## **FORD 4EOD NEW DESIGN SOLENOID PACK FOR 1995 VEHICLE HARNESS WILL NOT CONNECT TO A NEW SOLENOID PACK**

# Technical Service Information

Figure 1

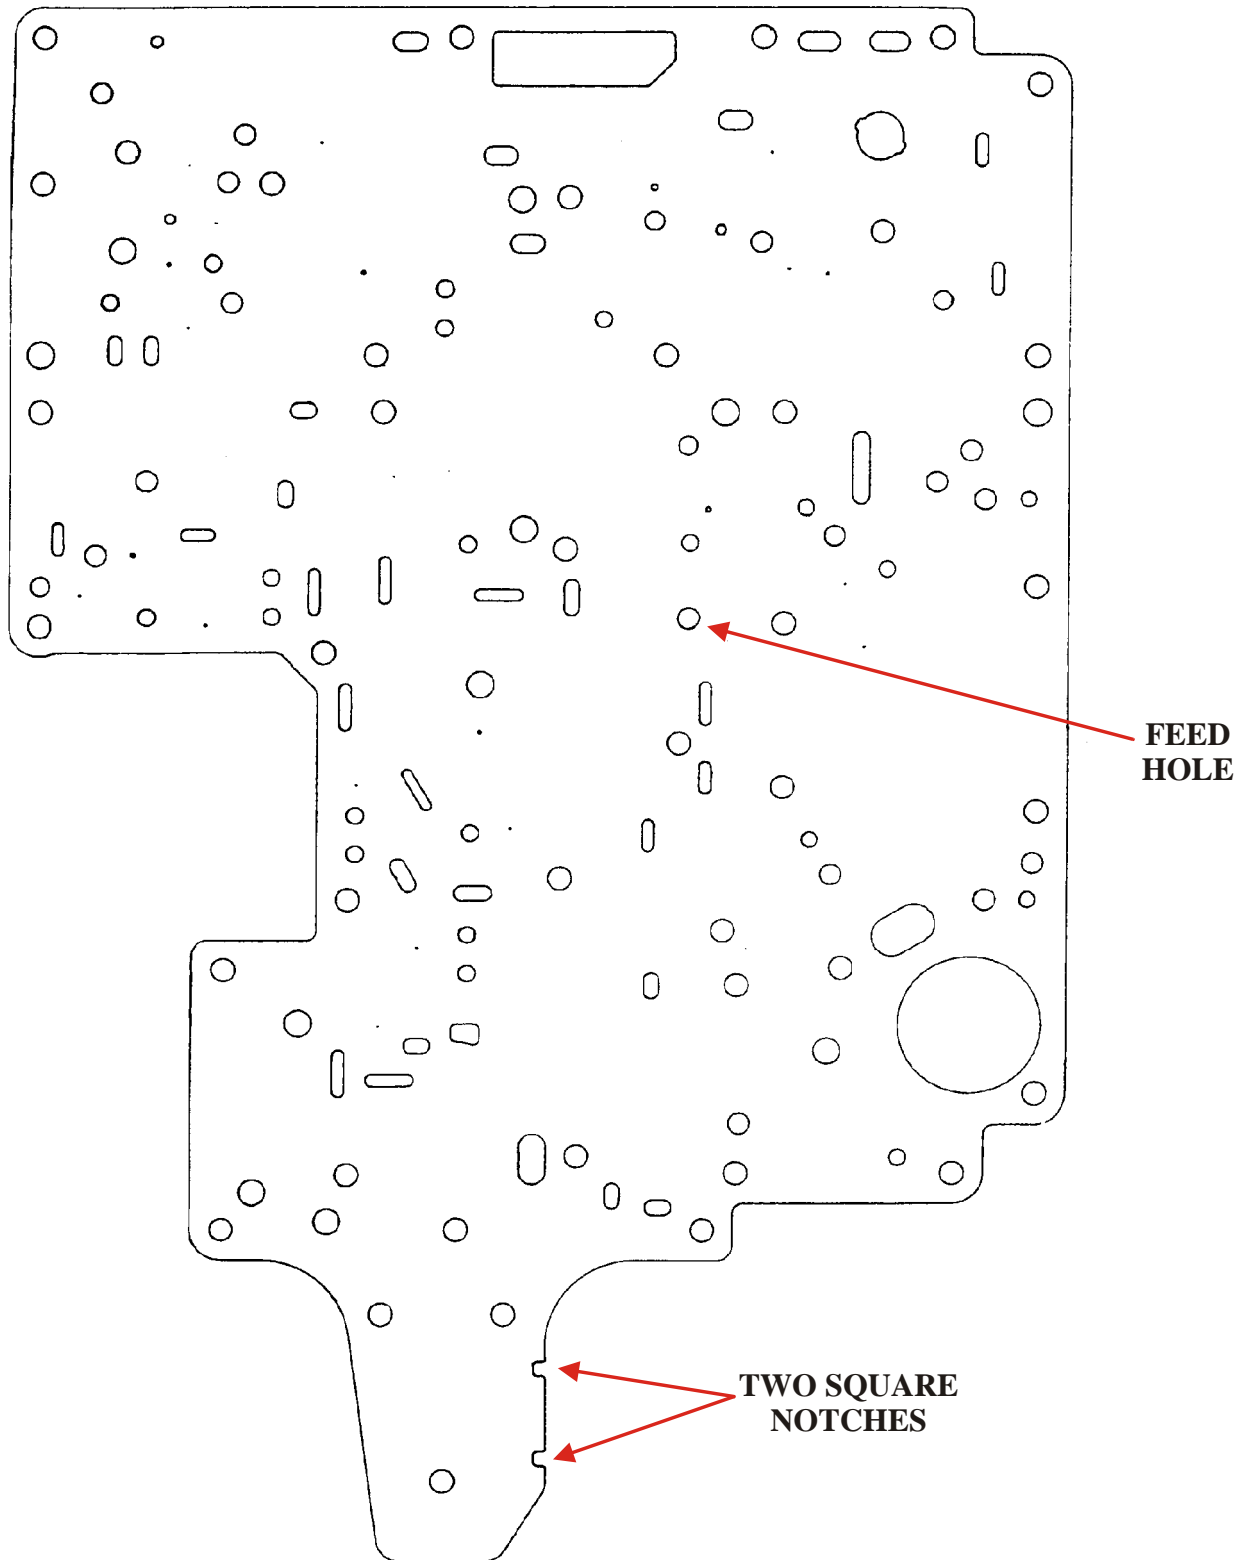
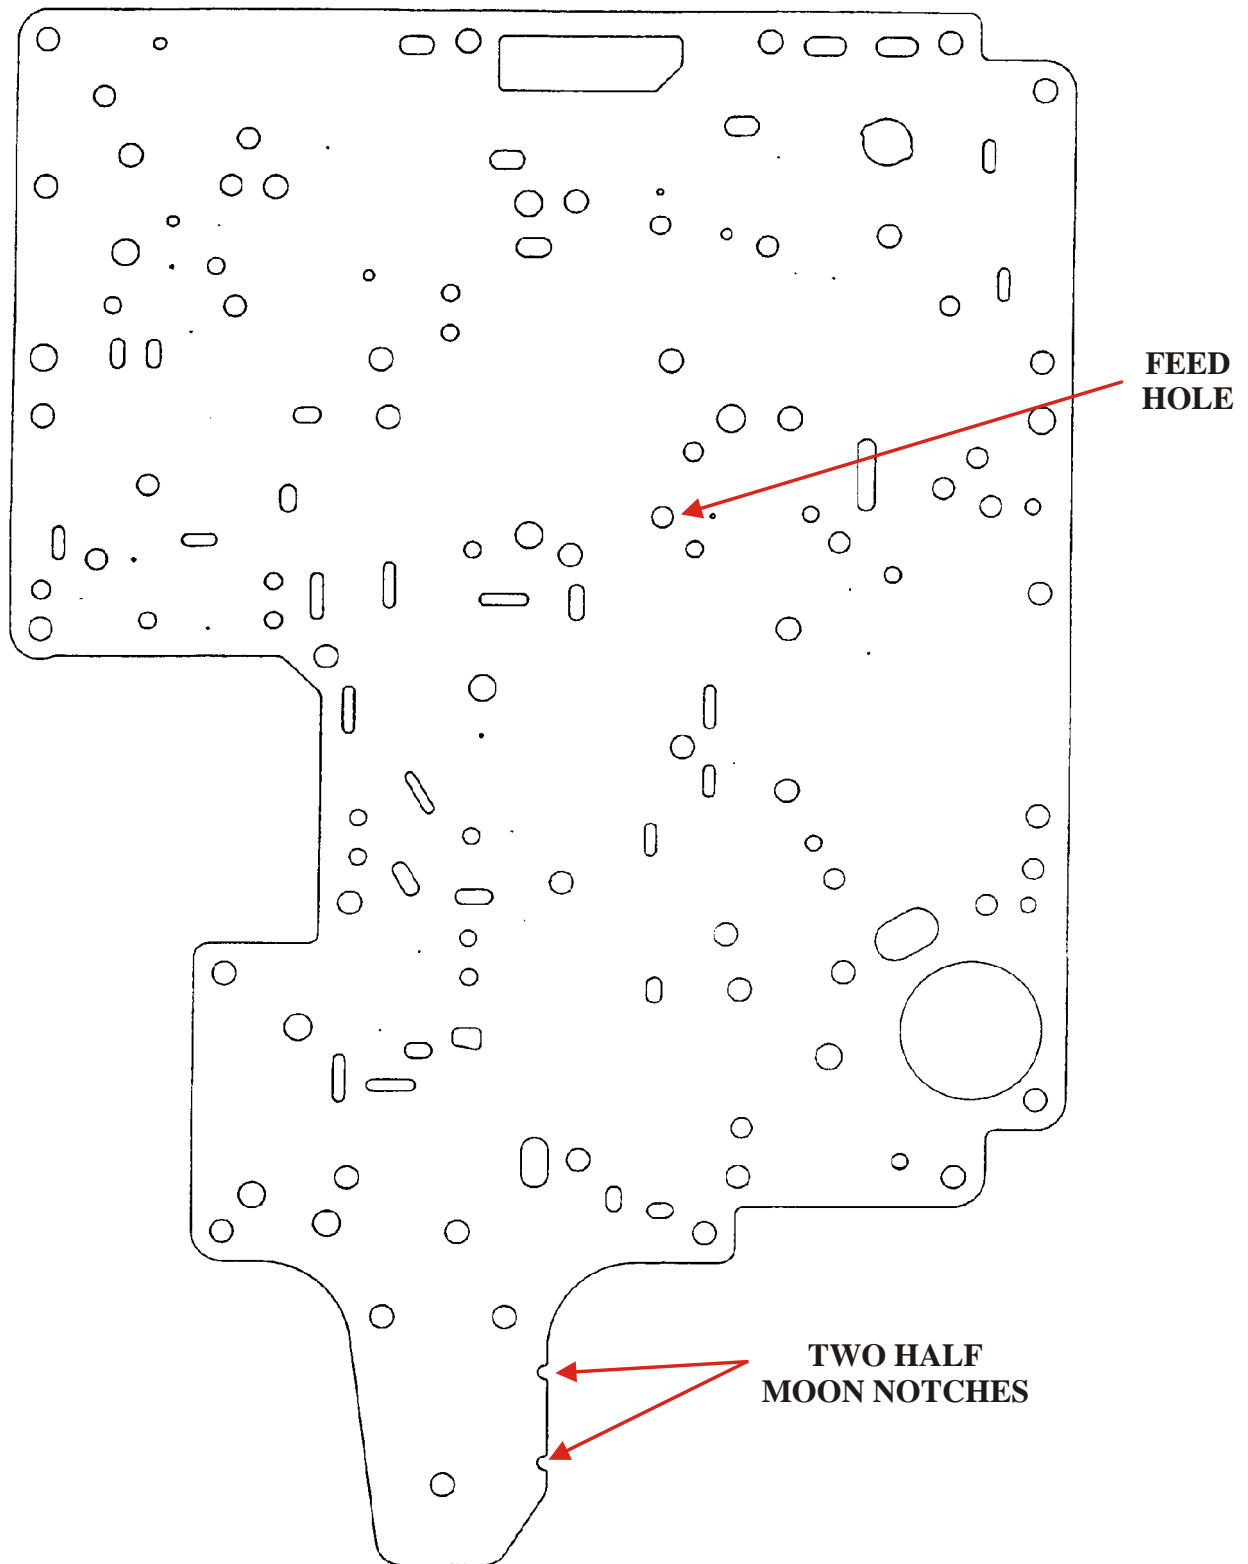
- PARTS AFFECTED:**
- (1) MAIN VALVE BODY SPACER PLATE - Can be positively identified by the solenoid feed hole location, as shown in Figures 1 and 2. Can also be identified by the shape of the I.D. notches in the spacer plate, as shown in Figures 1 and 2.

- (2) VALVE BODY GASKETS - Must have solenoid feed hole locations in the gaskets that match the solenoid feed hole locations in the spacer plate, as shown in Figures 1 and 2.

- (1) The 1989 main spacer plate must be used on 1989 case, with 1989 checkball locations, 1989 valve body gaskets, and 1989 Main Valve Body.
- (2) The 1989 Main Valve Body can be used on later models, but the 1990 Main Valve Body **MUST** be used on 90-UP models.
- (3) The Lower Valve Body and spacer plates should also be kept together, large (.312") hole with 1989 model, and small (.055") hole with 1990 models.

Figure 3

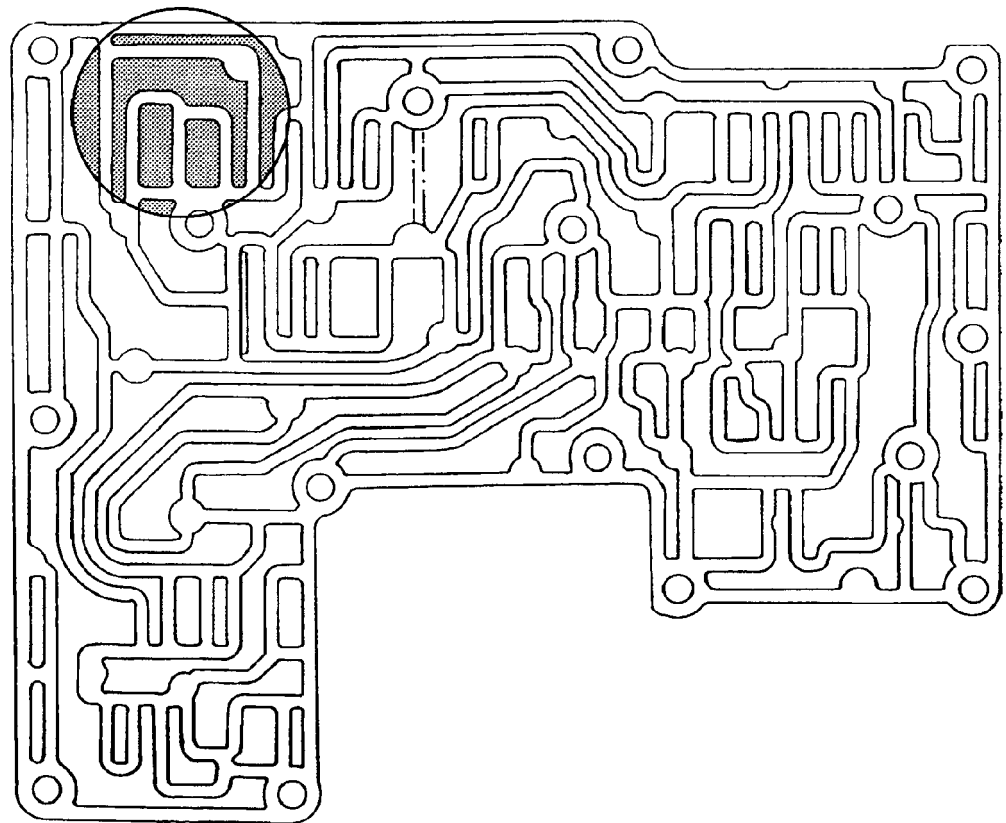
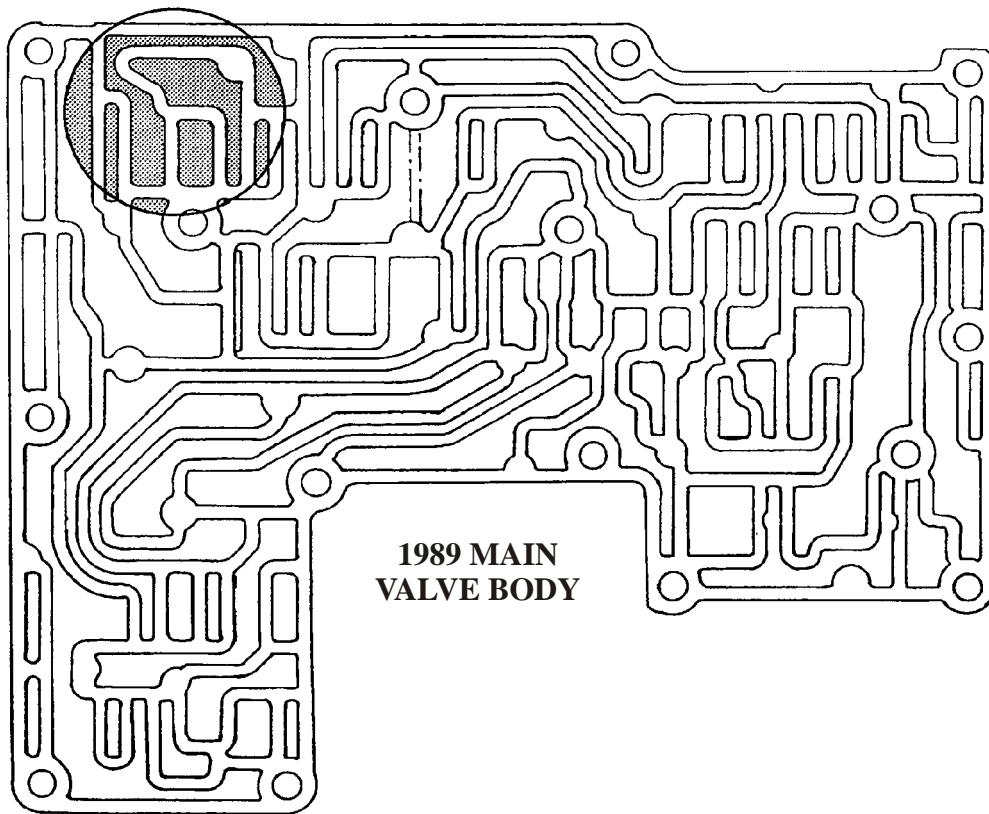
- (3) MAIN VALVE BODY - Can be identified by the differences in the worm track area at the 1-2 shift valve, as shown inside the circles in Figure 3. Can also be identified by the rough forging number cast into the valve body in the location shown in Figure 4.  
RF-E9TP-7A092 = 1989 Model  
RF-FOTP-7A092 = 1990 Model

Figure 5

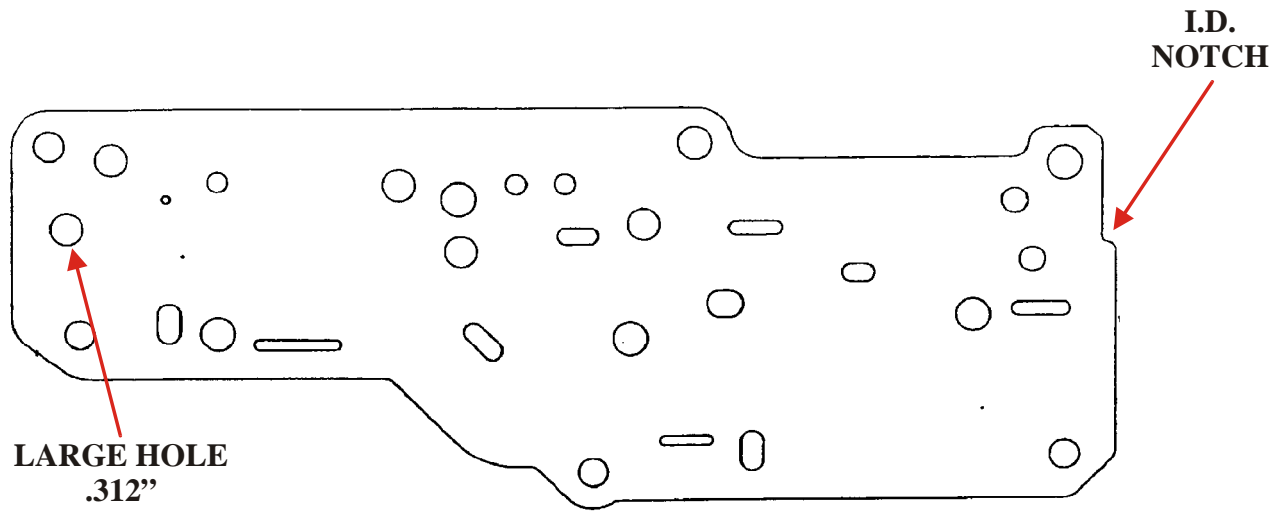
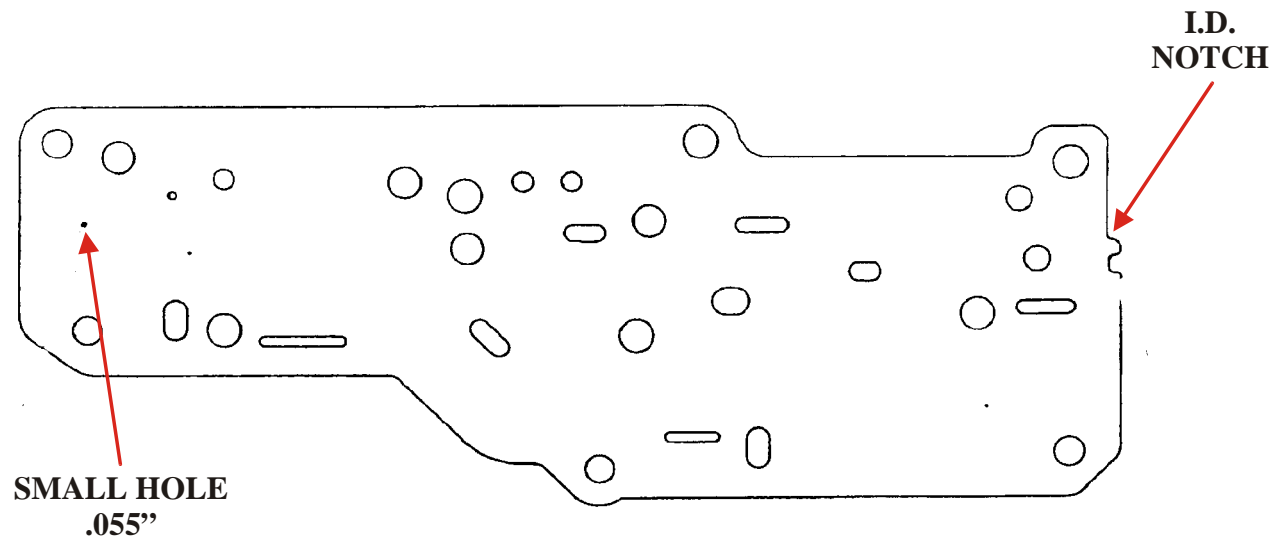
- (4) LOWER VALVE BODY SPACER PLATE - Can be identified by the diameter of the feed hole in the location shown in Figure 5. For 1989 models the hole diameter is .312", and for 1990 models the hole diameter is .055". They can also be identified by the I.D. notches in the spacer plate. 1989 plate has no notch and 1990 plate has one notch, as shown in Figure 5.

Figure 8

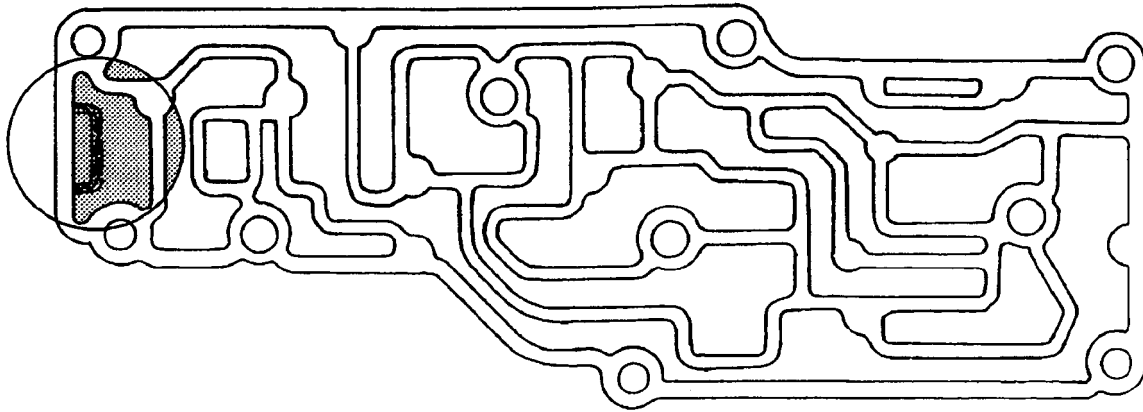
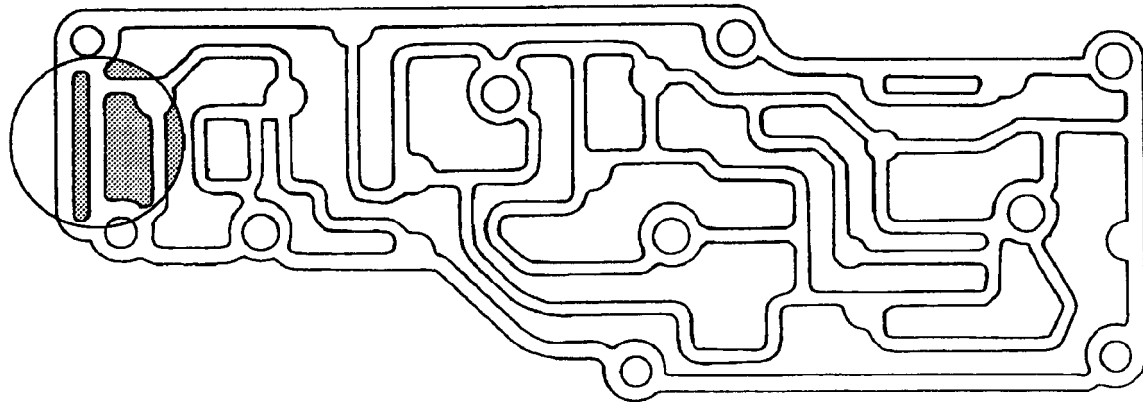
- (5) LOWER VALVE BODY - The engagement control valve retaining clip on 1989 models, was replaced by bore plug and new design clip on the 1990 model, which also changed the worm track configuration in that area, as shown inside the circles in Figure 6. The lower valve body can also be identified by the rough forging number cast in valve body.  
RF-E9TP-7A101 = 1989 Model  
RF-FOTP-7A101 = 1990 Model
